**Docket:** NRC-2016-0233

**Subject: Comments on Draft Regulatory Guide DG-1327, “Pressurized Water Reactor Control Rod Ejection and Boiling Water Reactor Control Rod Drop Accidents”**

GEH Comments on Draft Regulatory Guide DG-1327, “Pressurized Water Reactor Control Rod Ejection and Boiling Water Reactor Control Rod Drop Accidents”

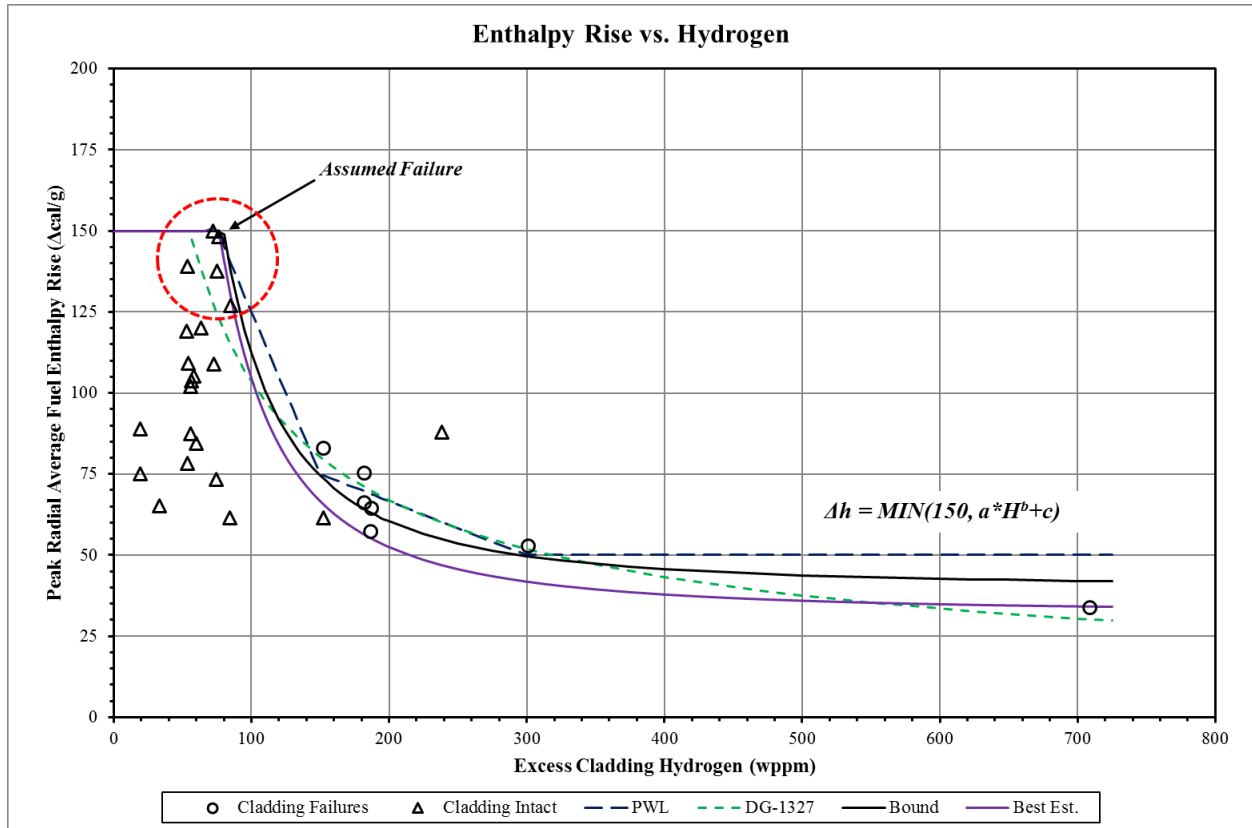
Regarding Figure 4, the staff elected to replace the previous piecewise linear (PWL) relationship with a curve fit through the data. To facilitate the curve fitting process, it was necessary to treat the highest non-failure enthalpy/hydrogen content point (72 wppm, 150 cal/g) as a presumed failure point. This presumed failure point should serve as an anchor point for the curve fit. The current curve instead omits three other non-failure points.

The primary response from a CRDA is often from the fresh fuel (i.e. lower exposure) with highly exposed fuel reacting less energetically. Thus, the purposed failure threshold is less accurate in the area of interest particularly between 55-to-100 wppm. The figure below illustrates both a best-fit and a lower bound alternative using an exponential function.

Where  $\Delta h$  is the enthalpy change and  $H$  is the excess hydrogen. In these examples, the best fit coefficients are:  $a = 3.31E+5$ ,  $b = -1.83$ , and  $c = 32$ . While the lower bound coefficients are:  $a = 3.31E+5$ ,  $b = -1.83$ , and  $c = 40$ .

Please redraw the curve to encompass more of the actual non-failure data points. While this comment directly pertains to Figure 4, the same concept applies to the other fitted curves.
